UNITED KINGDOM HOLOCAUST MEMORIAL & LEARNING CENTRE

Design and Access Statement
January 2026 Addendum

Proposed Roof Level - Option 1E

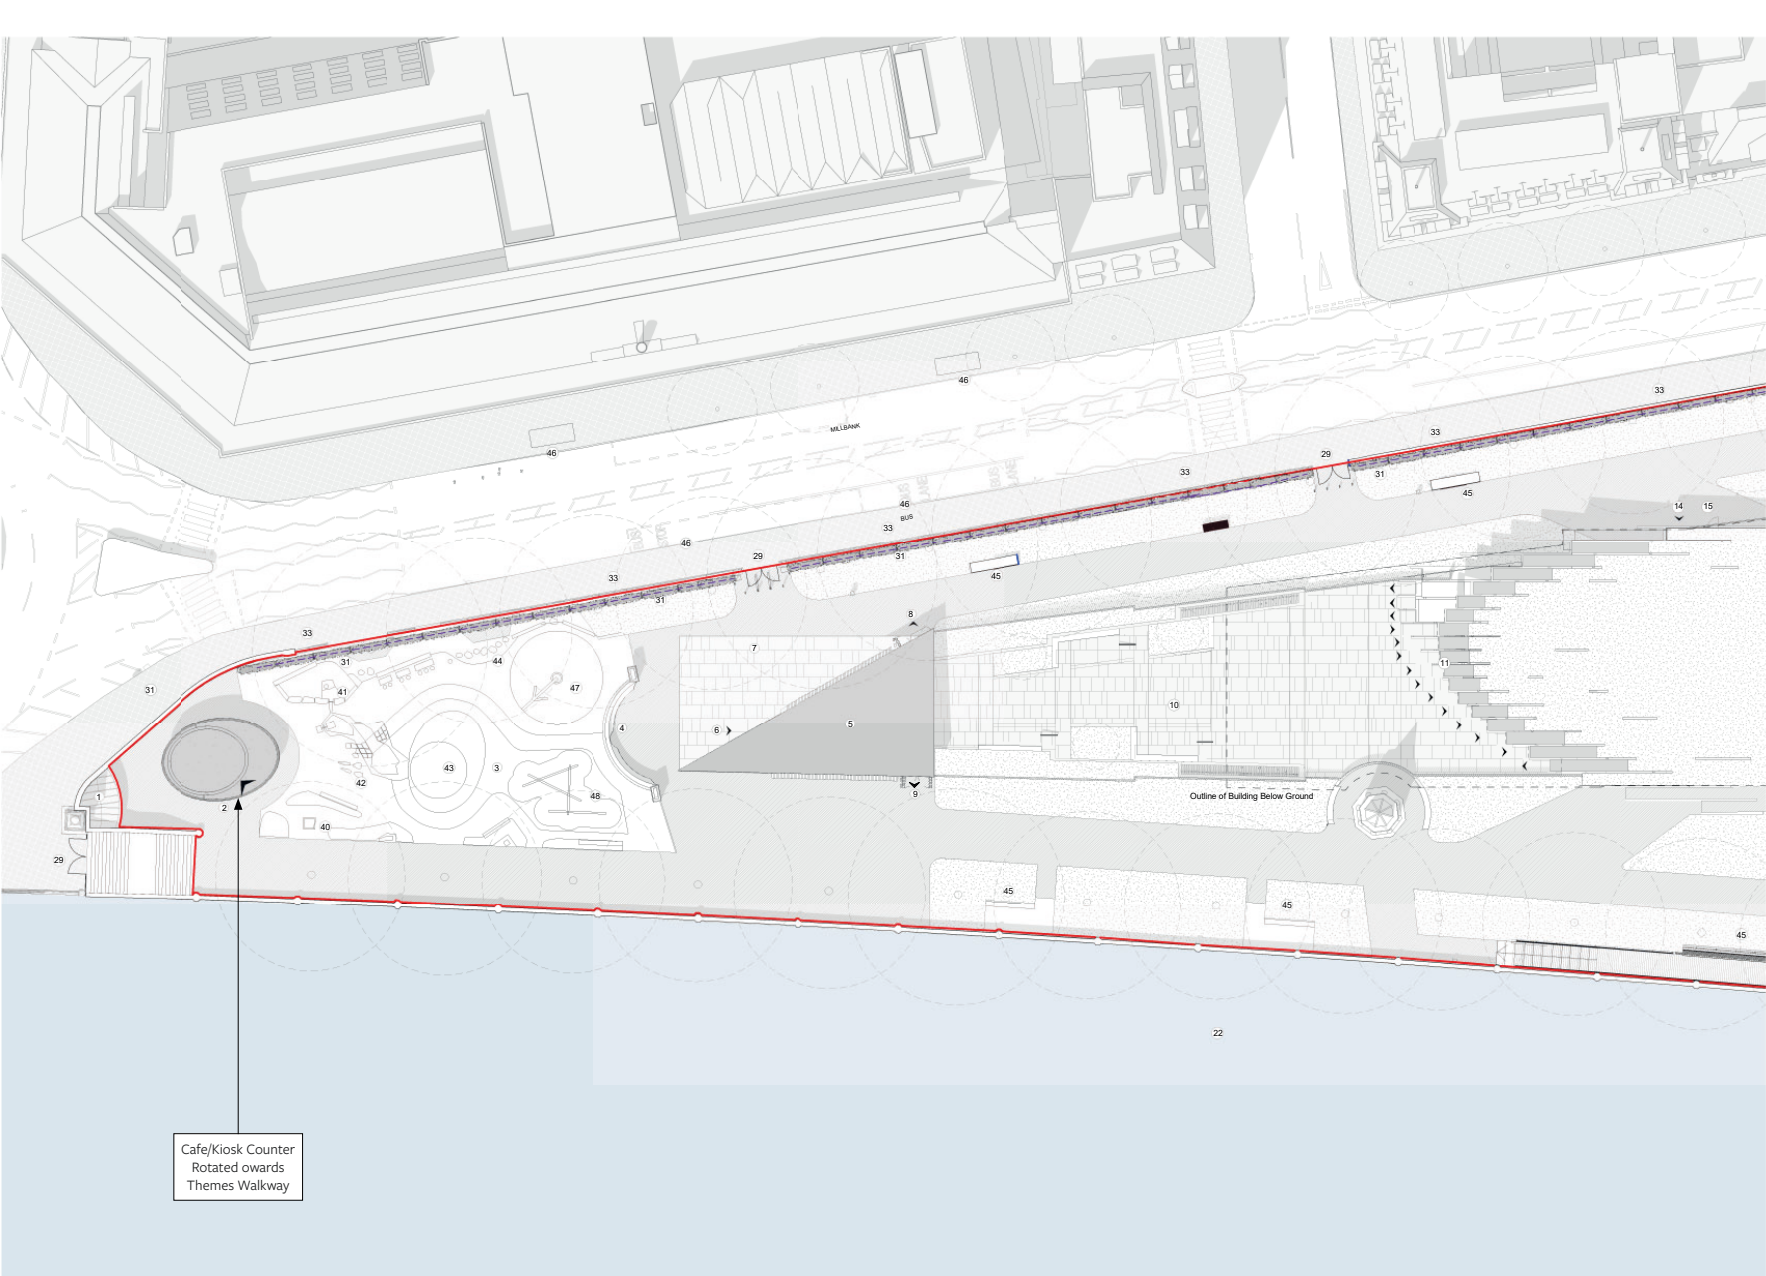
The counter of the Cafe/Kiosk opens more towards Thames Walkway.

The counter of the Café/Kiosk opens more towards Thames Walkway to mitigate any conflicts with playground users.

Drawing Title: Proposed Roof Level - Option 1F

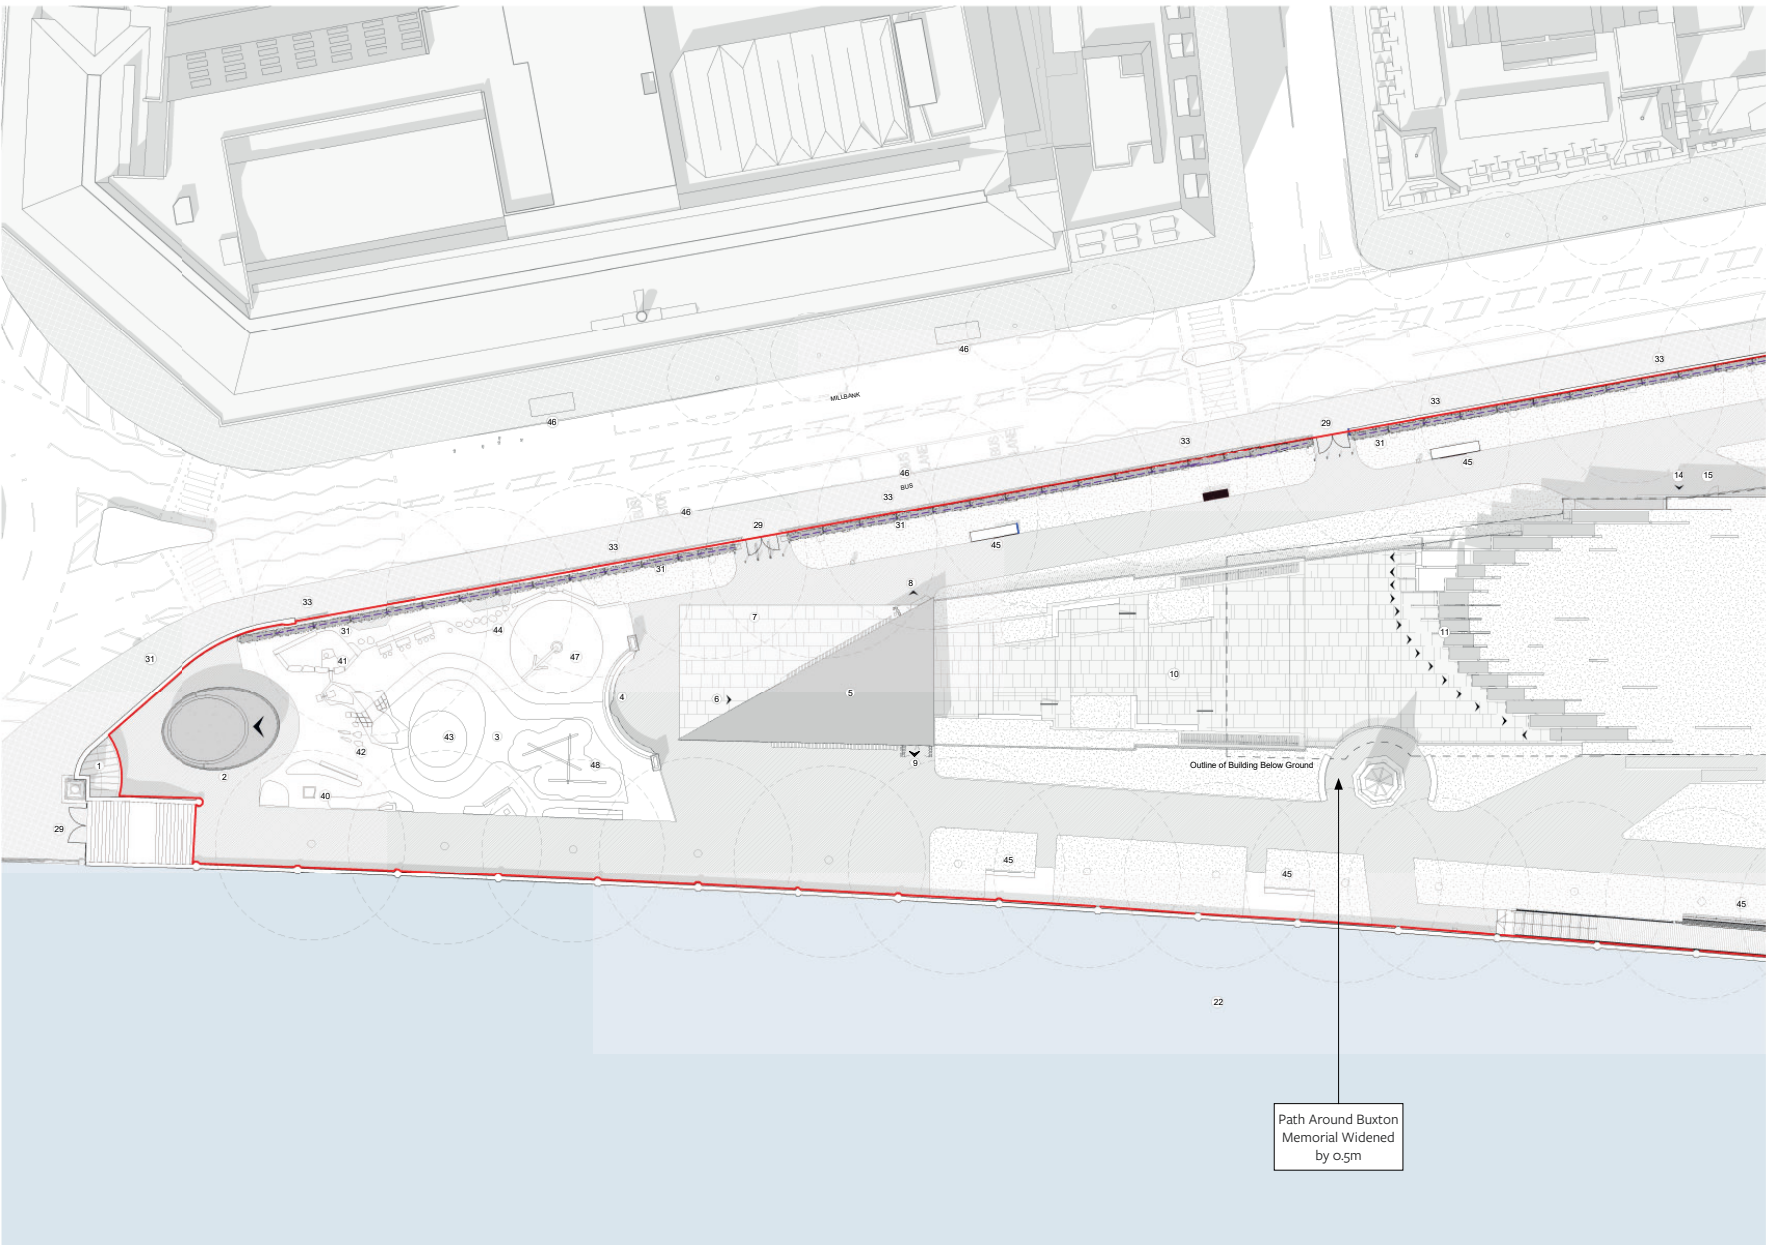
The path surrounding the Buxton Memorial could be widened by 0.5 metres.

Option 1F - BUXTON MEMORIAL WIDENED PATH
The path surrounding the Buxton Memorial could be widened by 0.5 metres. This adjustment may be considered to provide additional space for visitor circulation.
